**CONTRACT ADDENDUM #**

**date:** 5.10.24  
**project:** Hyde Park Middle School  
**by:** Michael Rigby  
**subject:** Addendum 02

**HPMS ADDENDUM #2**

**SUBJECT:** **Addendum #2 – Changes to Bid Package #1**

**END 350 WEST STREET**  
 SCALE: 1"=20'

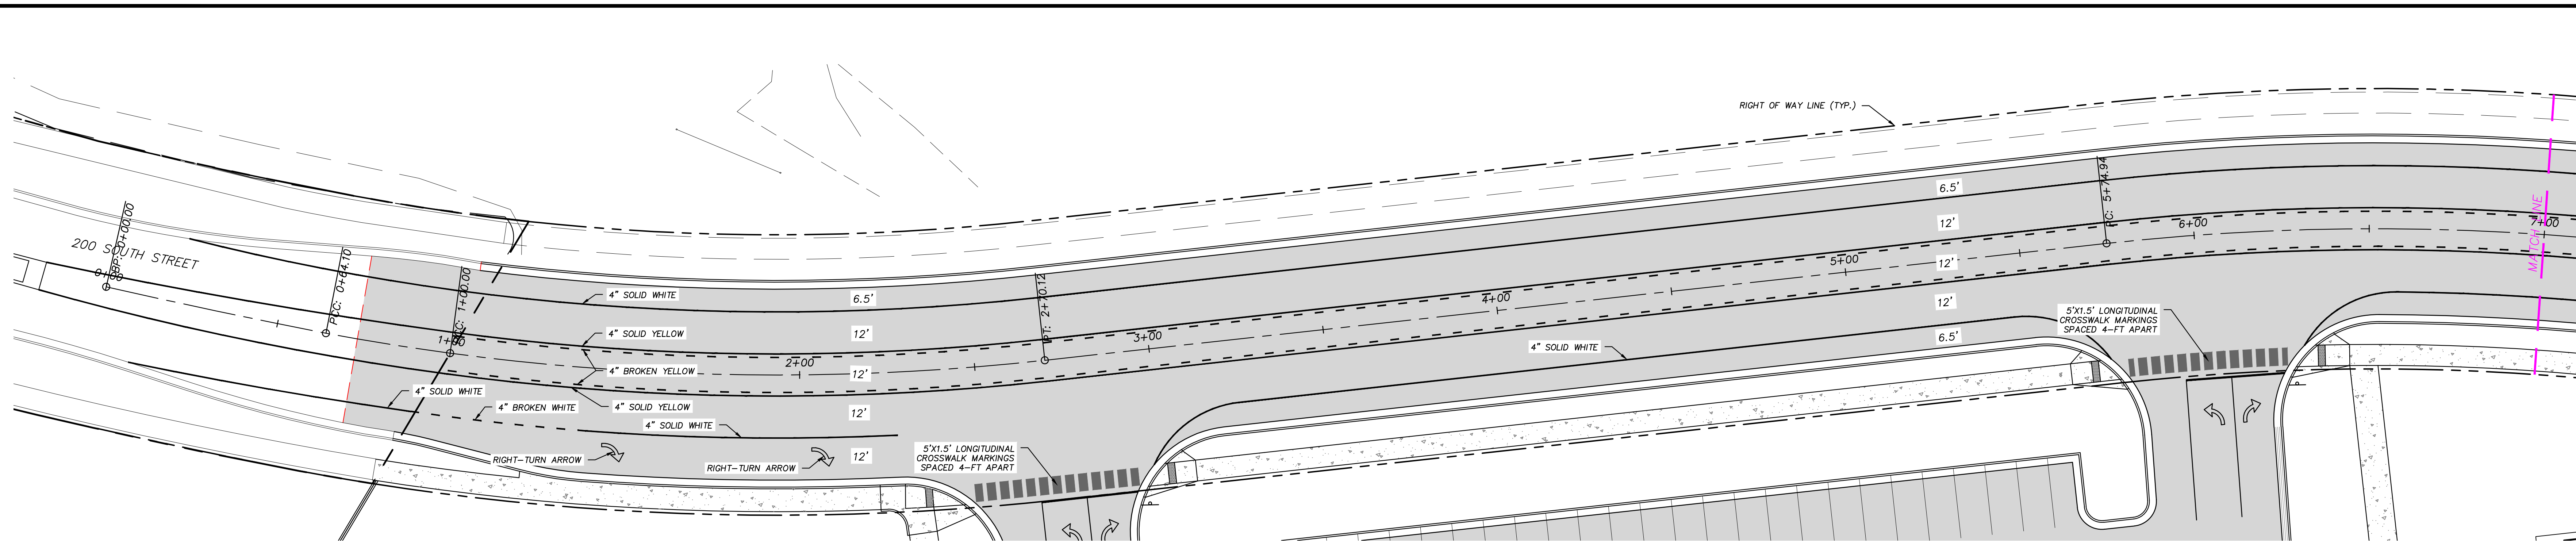
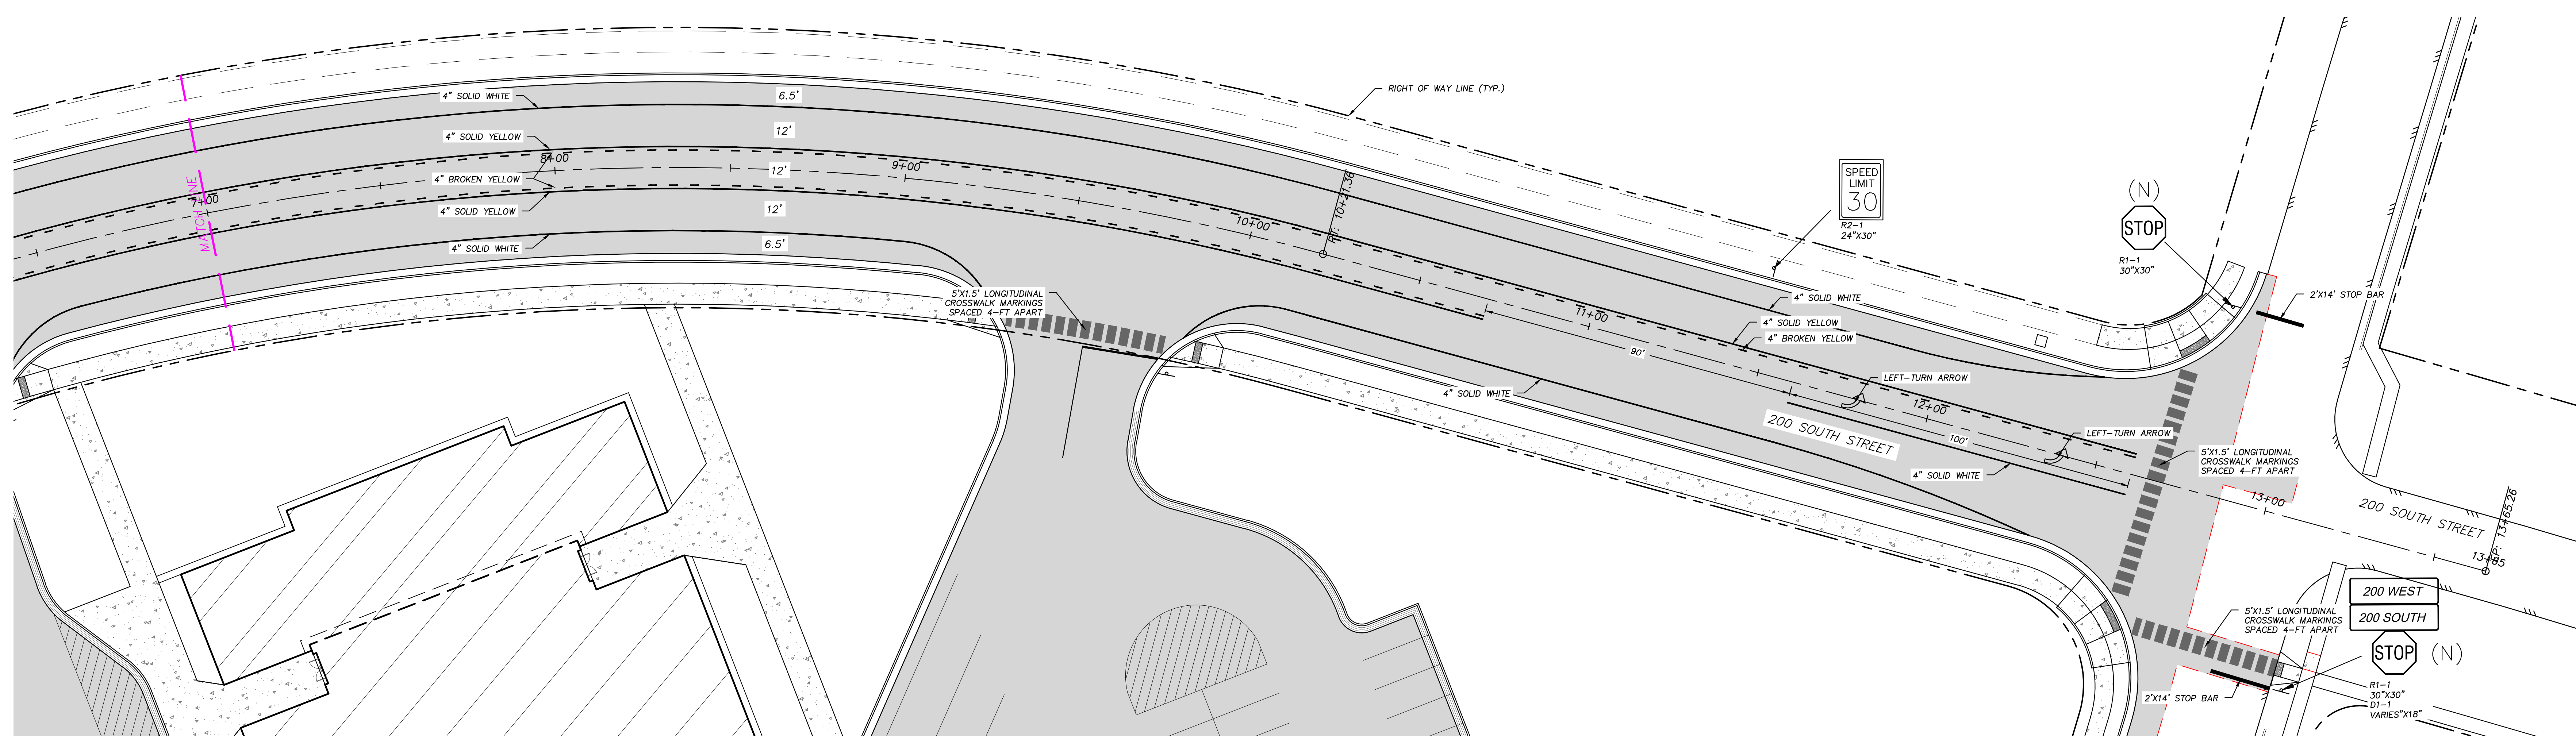
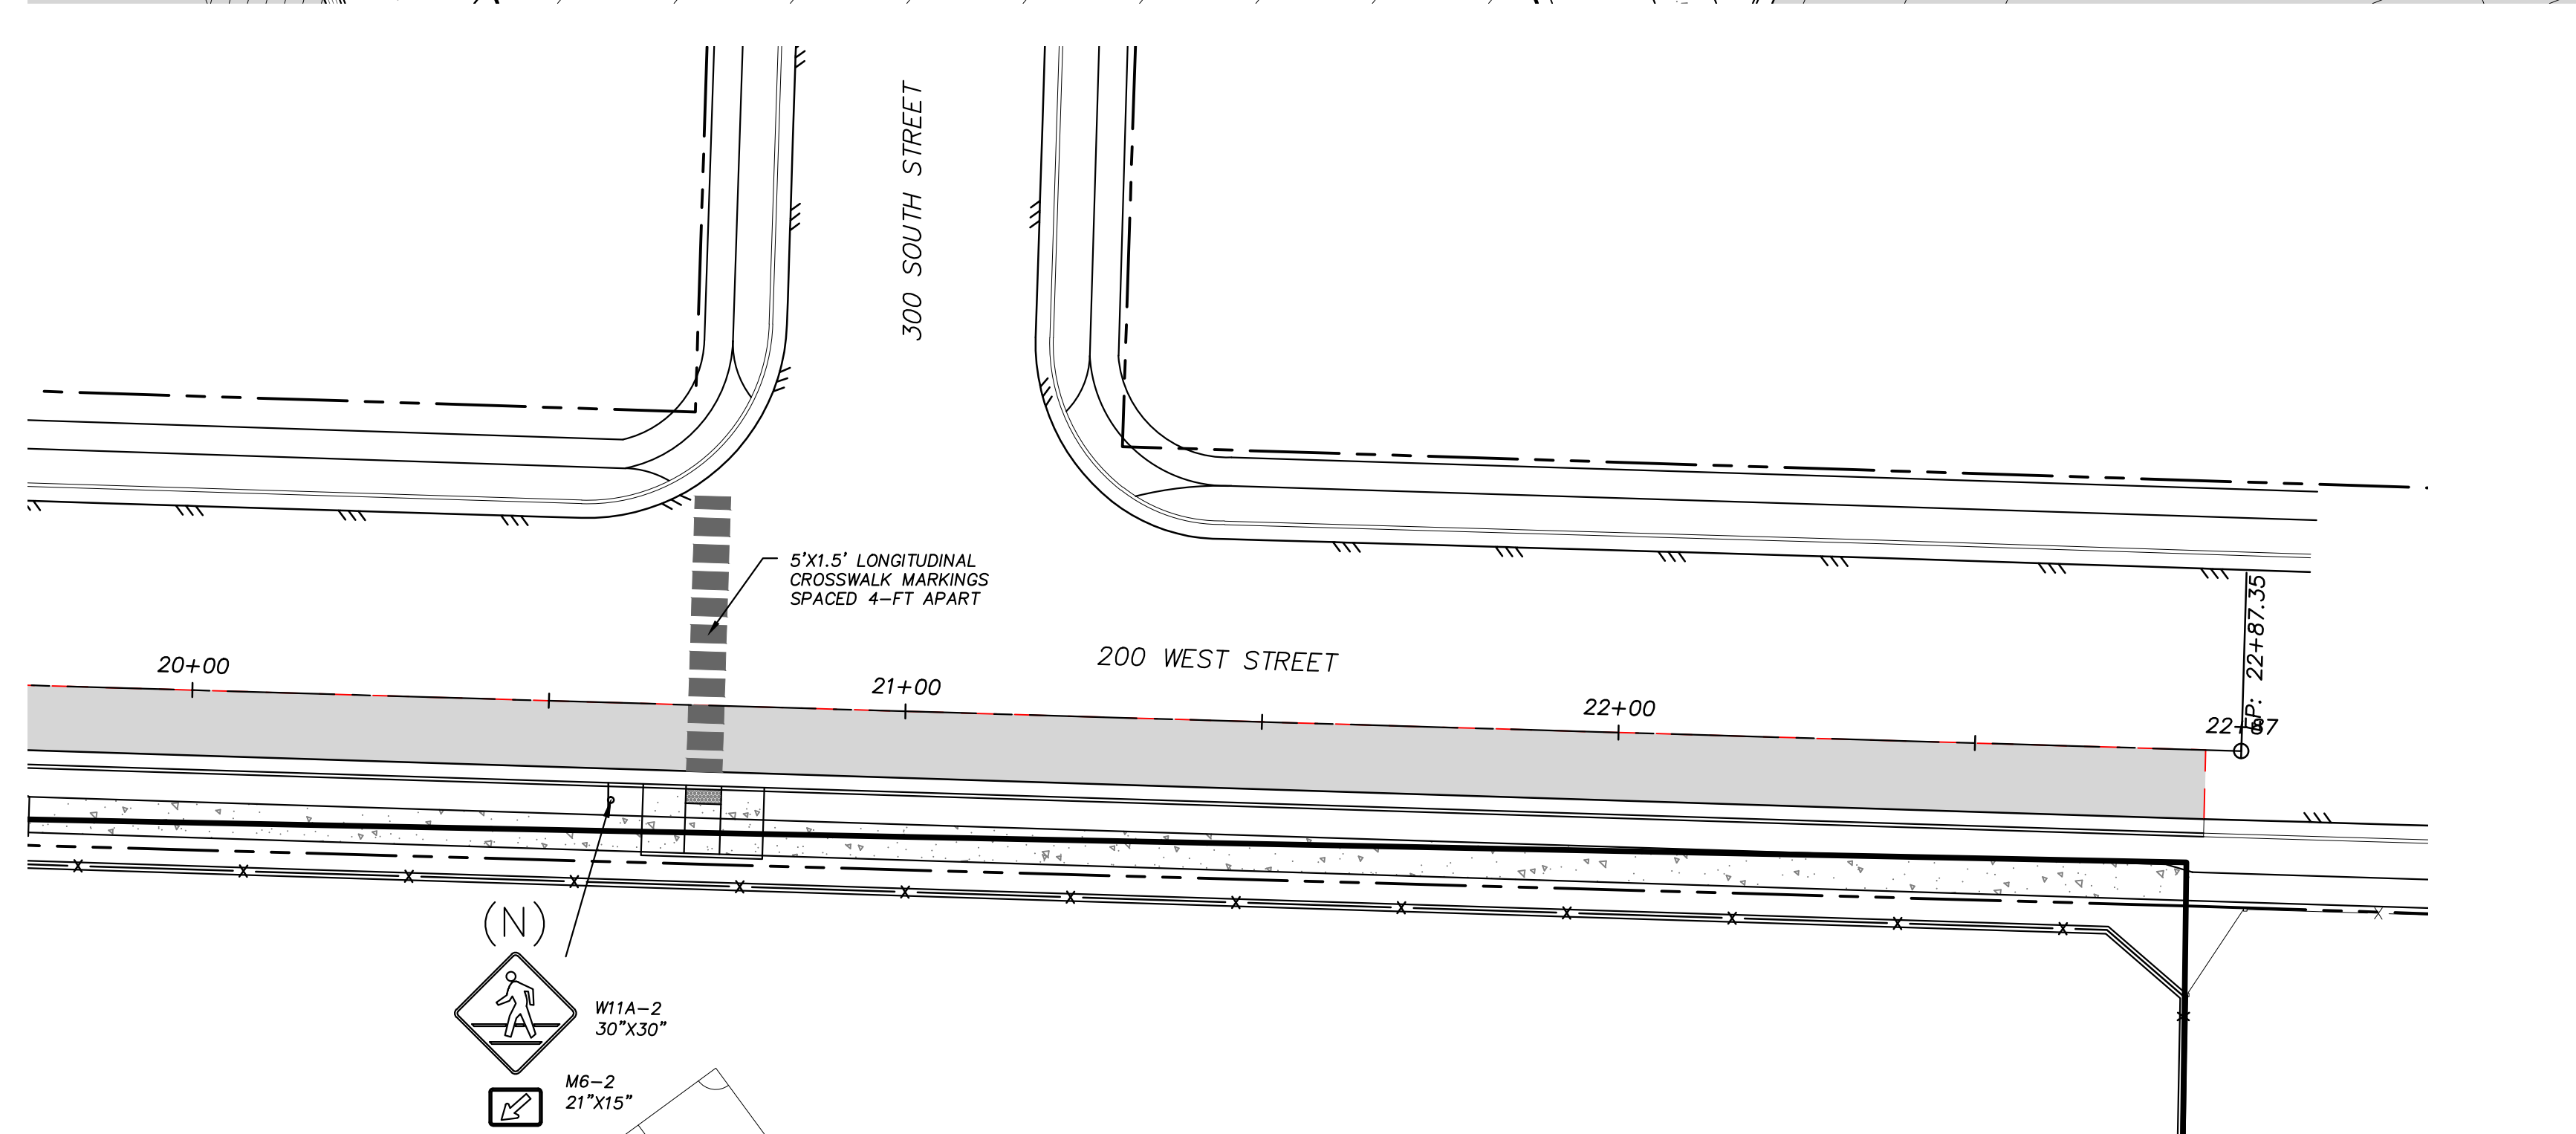
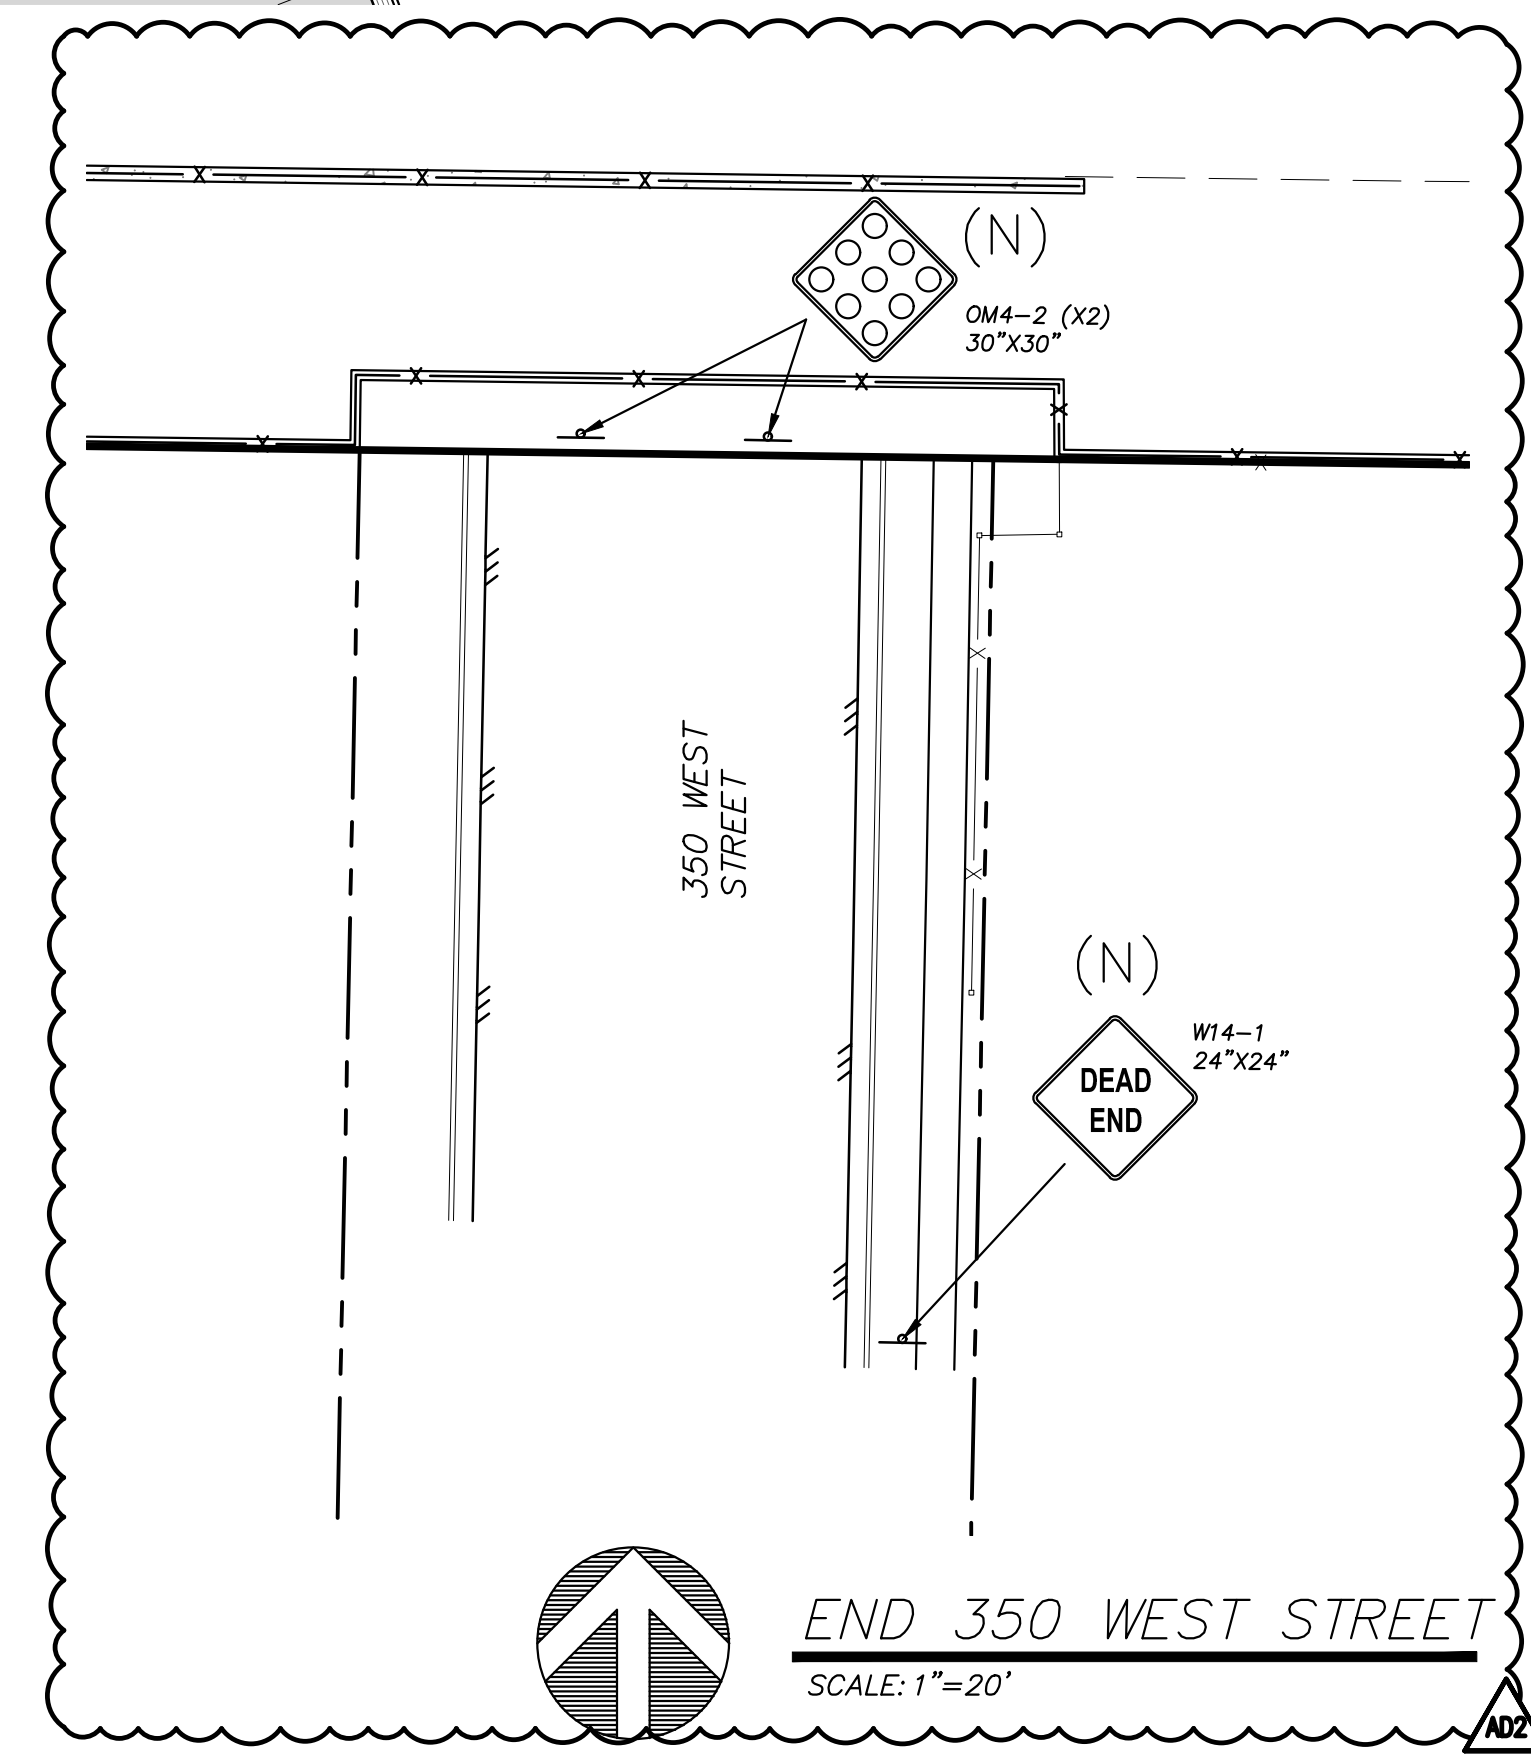
- 8. Civil – Roadway Signage & Striping, Sheet C-701.**
  - a. ADDED** – Dead end sign for 350 West Street.
  - b. ADDED** – End of road sign (x2) for 350 West Street.
